To: Plan Holders for Improvements to the
Kirksville Regional Airport
Kirksville, Missouri
Project No. 14-028A-3
Reconstruct Air Carrier Apron (Schedule I), Reconstruct South Apron (Schedule II),
and Reconstruct T-Hangar Taxilanes (Schedule III)

Transmitted herewith is Addendum **No. 2** to the Contract Documents, Plans and
Specifications dated May 19, 2015 for Improvements to the Kirksville Regional
Airport, Kirksville, Missouri, Project No. 14-028A-3.

**ADDENDUM NO. 2
TO
CONTRACT DOCUMENTS, PLANS AND SPECIFICATIONS
FOR IMPROVEMENTS TO THE
KIRKSVILLE REGIONAL AIRPORT
KIRKSVILLE, MISSOURI
PROJECT NO. 14-028A-3**

GEOMETRIC PLAN SCHEDULE I			SHEET NAME
AIP PROJ. NO. 14-028A-3	JVIATION PROJ. NO. 2015-IRK-01	DATE: 05/19/2015	C201
			SHEET NO.
			15 of 32

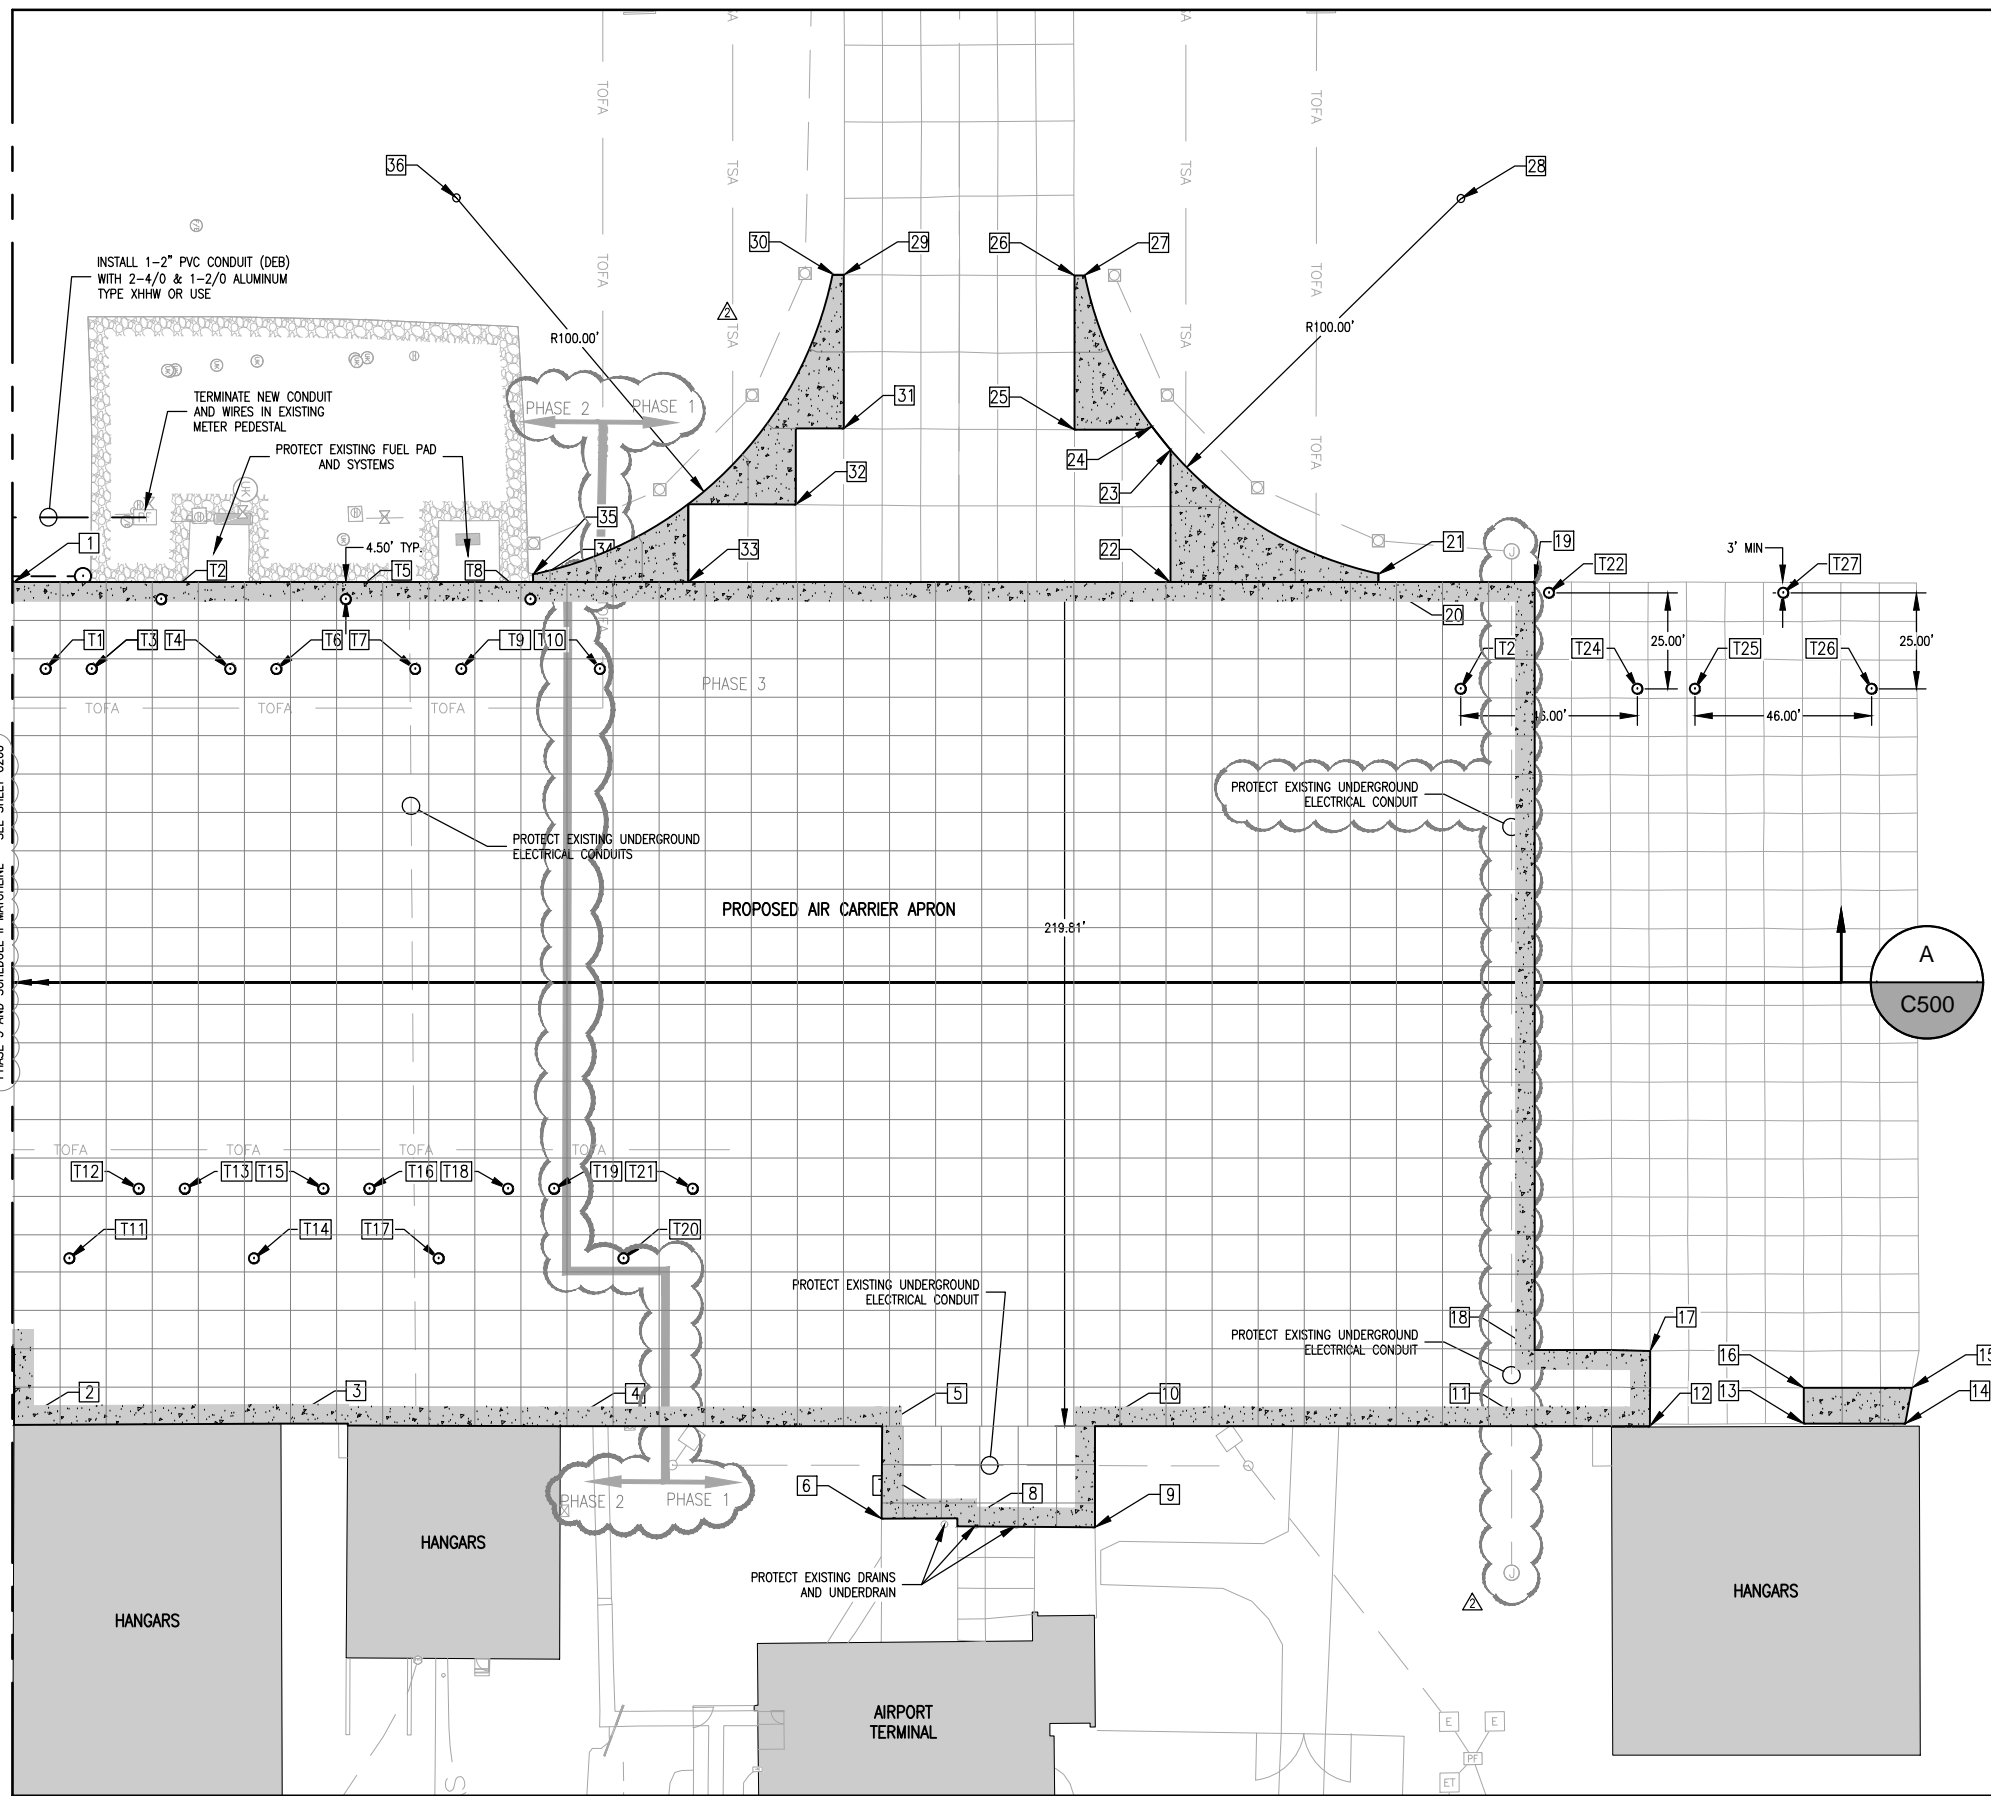
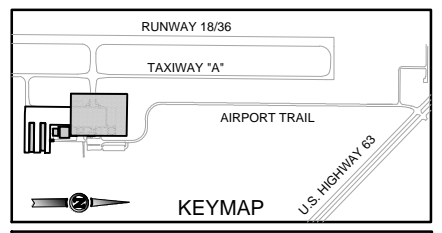
Sheet: C201
Title: Geometric Plan, Schedule I
Revision: The location of the phasing breaks has been added.
See attached sheet C201.

2. With the phasing splitting the schedules up there is no detail on the plans (demo, geometric, grading, or joint) showing the limits of each phase. This information would be a great help for both bidding and construction. Could you possibly show the limits of these so we know where to remove and replace to for each phase?

Answer: See revised plan sheets C200 and C201.

A
SECTION A-A (SCHEDULE I)
C500
N.T.S.

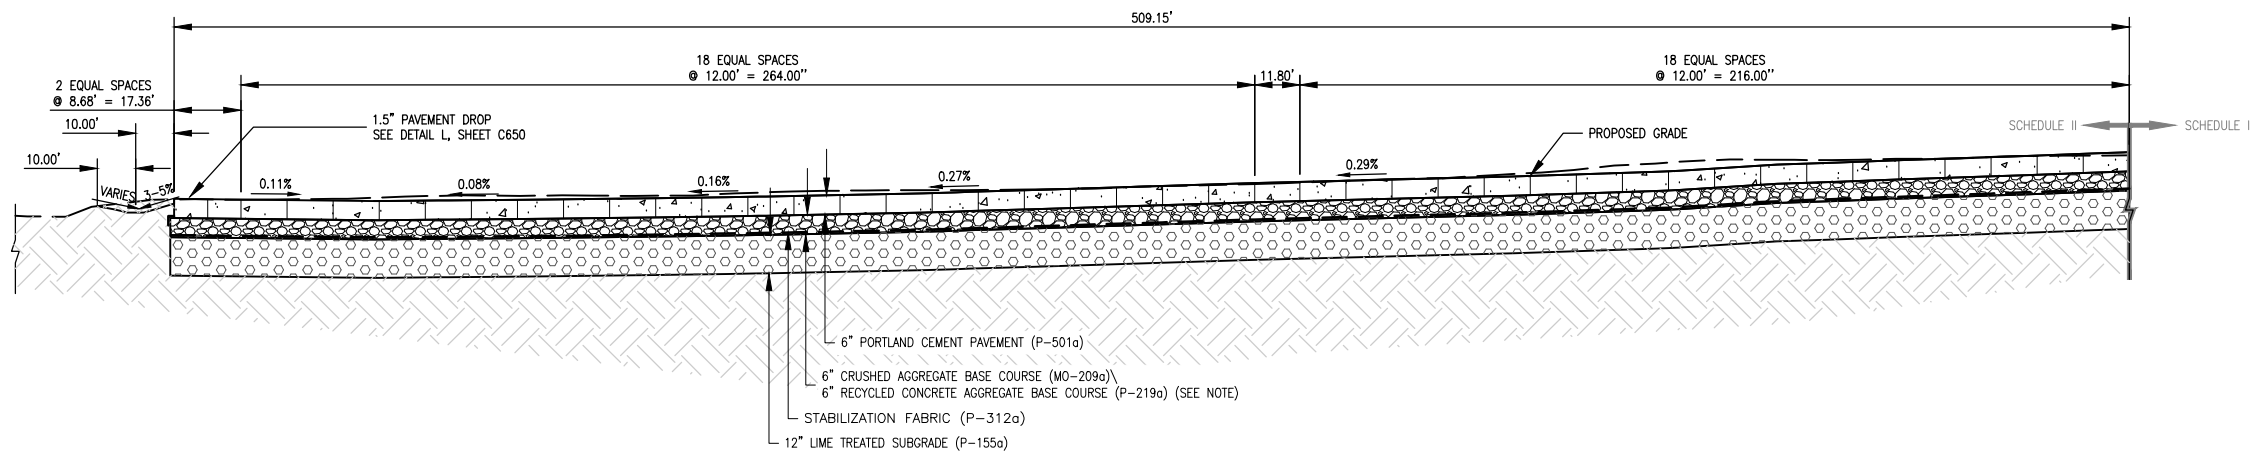
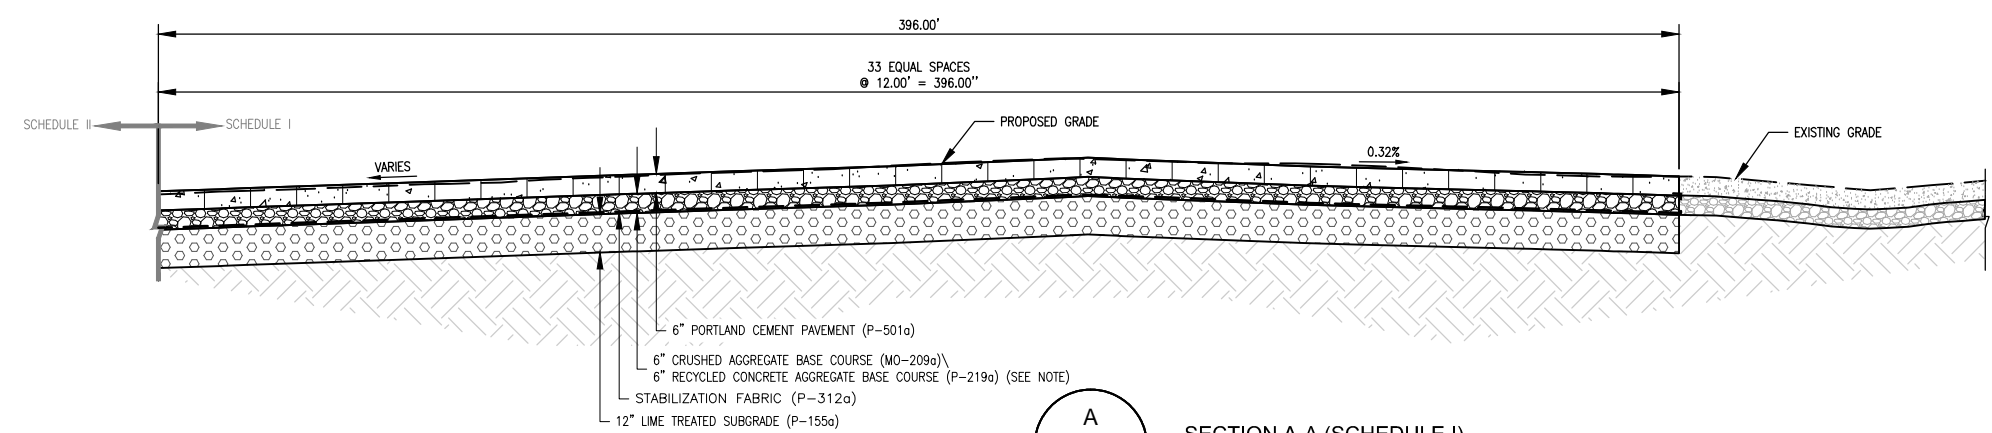
Sheet: C500
Title: Typical Sections
Revision: The note for the Base material has been revised to clarify the requirements of the two bid alternates.
Revision: The distance between the Existing Hangars has been corrected from "52.00" to "72.70" on Section B-B (Schedule III).
See attached sheet C500.

1. Can the MO-209 base be used instead of the P-219 material or can the MO-209 be used for phase 1 and then use the crushed concrete for the additional phases?

Answer: Alternate Bids have been added to the project to allow for either:

- IF RECYCLED CONCRETE AGGREGATE BASE ALTERNATE IS BID, M0-209 TO BE USED WHERE THERE IS A SHORTAGE OF P-219 MATERIAL, AND SHALL BE PAID FOR AS P-219 MATERIAL.
- IF CRUSHED AGGREGATE BASE ALTERNATE IS BID, ALL MATERIAL USED SHALL BE M0-209.
